PLANNING COMMISSION STAFF REPORT

FOR CONSIDERATION BY PLANNING COMMISSION ON JANUARY 23, 2024

PRIMROSE CREEK SUBDIVISION – SECTION 3 EXPANSION – DESIGN PLAN

Re: Primrose Creek Subdivision – Section 3 – Design Plan Review

Primrose Creek Subdivision SECTION 3 DESIGN PLAN - EXPANSION/MODIFICATION EZEKIAL HOWELL M.S. NO. 1767 MIAMI TOWNSHIP, CLERMONT COUNTY, OHIO

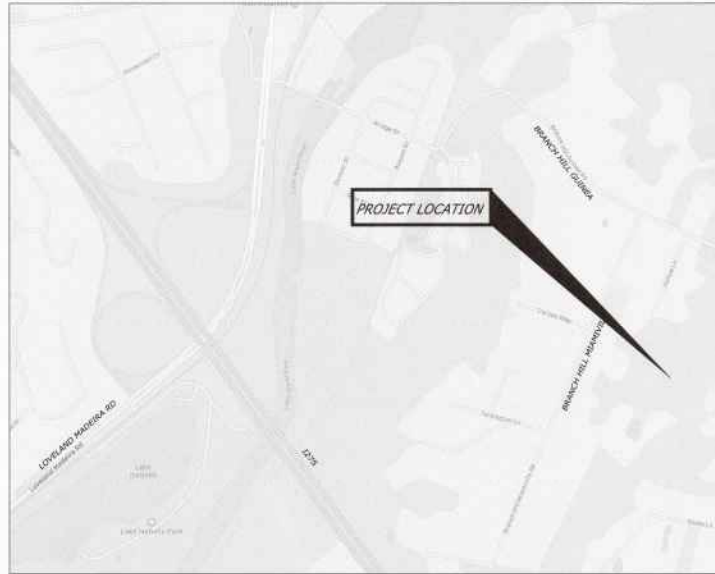
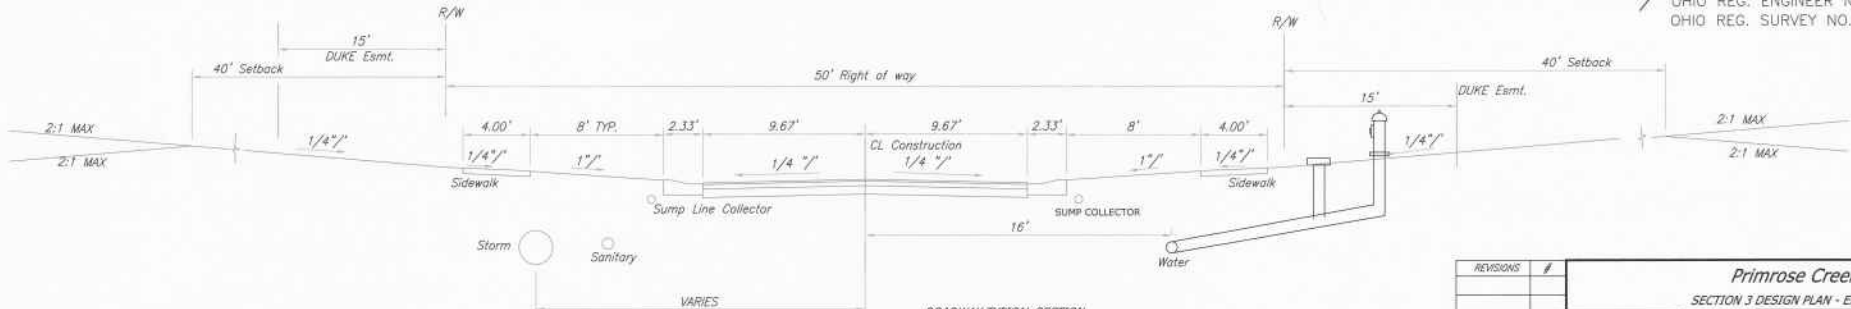
2. Label the width of the right-of-way of Conner Lane on the drawing.
3. Some notes on the cover sheet are repeated.
4. The variance is for cul-de-sac length, cul-de-sac requirement also states no more than 30 units can be served - existing cul-de-sac is for 32 units.
